45.7060.R1:GA/DT/2015

Ashfield Council
260 Parramatta Road
ASHFIELD NSW 2131

REVIEW OF ACOUSTIC ISSUES
WESTCONNEX M4 EAST EXTENSION PROJECT (STAGE 1)
OPERATIONAL NOISE AND CONSTRUCTION NOISE AND VIBRATION
ASHFIELD LOCAL GOVERNMENT AREA

Diagram 3 - Axonometric from EIS at Appendix L - Eastern Facility Site at corner Wattle Street and Parramatta Road.

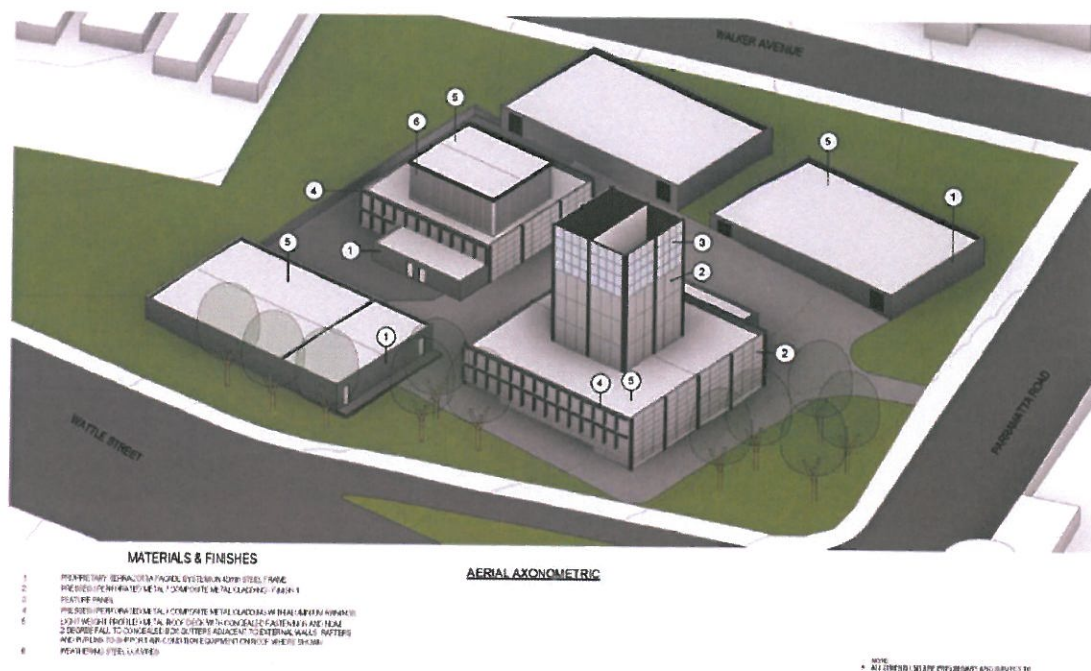
Visual impact and outstanding design development of eastern ventilation stacks and ancillary buildings and the site's open space.

(iv) The corner of Parramatta Road and Wattle Street will contain a large site with several visually prominent buildings, including very tall 25 metre high ventilation exhaust stacks which will obviously have long distance visual impacts (see Diagram 3). The precise aesthetic composition of those buildings needs to be carefully resolved in a way that notes and acknowledges the Haberfield context and is not blandly modularly simplistic. There are standard compositional canons that one would normally make use of, together with some creative interpretative imagination. The open space setting and landscape design of the site should have high design standards, e.g. there shouldn't be cyclone wire mesh security fencing. A stretch of 125 metres of the site is actually adjacent residential properties in Walker Avenue. Similar comments apply to the construction sites on the west corner of Wattle Street and Parramatta Road.

Diagram 5 – Area corner Bland Street and Parramatta Road

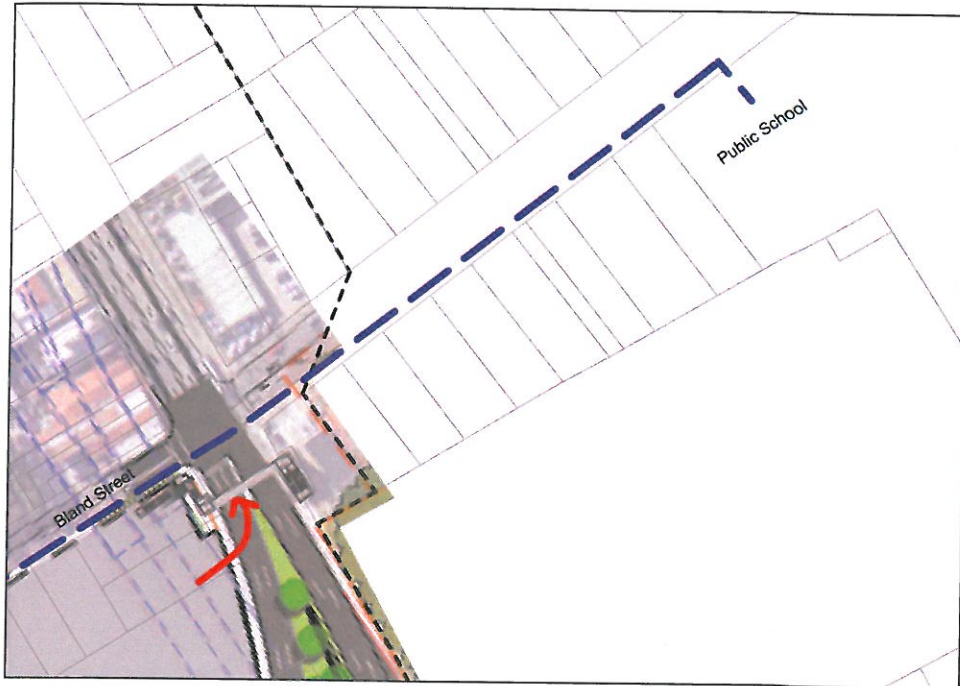
(ix) This area is approximately 500m long with the north and south sides of Parramatta Road clearly being significantly separated from each other in this location. Approximately 250 metres along the south side will contain no buildings – and so no street/road activation for pedestrian surveillance. There will be no safe means of pedestrian crossing for approx 655 metres between Dalhousie Street and Bland Street. A pedestrian bridge would contribute to better north south connectivity, and could potentially be placed on or adjacent to residual land at 162 Parramatta Road and span across the road to be near the Presbyterian Aged Care home at 169 Parramatta Road. The bridge would also provide surveillance of the area along Parramatta Road, and act as visual/sculptural portal and so bring aesthetic interest to this part of the roadway which will be up to 60 metres wide (equivalent of 20 traffic lanes). It is also relevant that Parramatta Road is a historic road, and so some thematic acknowledgement of this could be integrated into a new pedestrian facility. If such a bridge was not technically feasible, as a minimum substantial public art should be installed along this part of the road.

(x) The area at Bland Street south of Parramatta Road is used by schoolchildren to access the Haberfield Public school to the north (see blue line in Diagram 5). The EIS states that trucks will be using Bland Street as an exit to access Parramatta Road. This is a major public safety concern and an unacceptable traffic arrangement at this significant pedestrian crossing point. Ideally, trucks should only exit onto Parramatta Road directly, and the existing Bland Street bridge kept in operation.
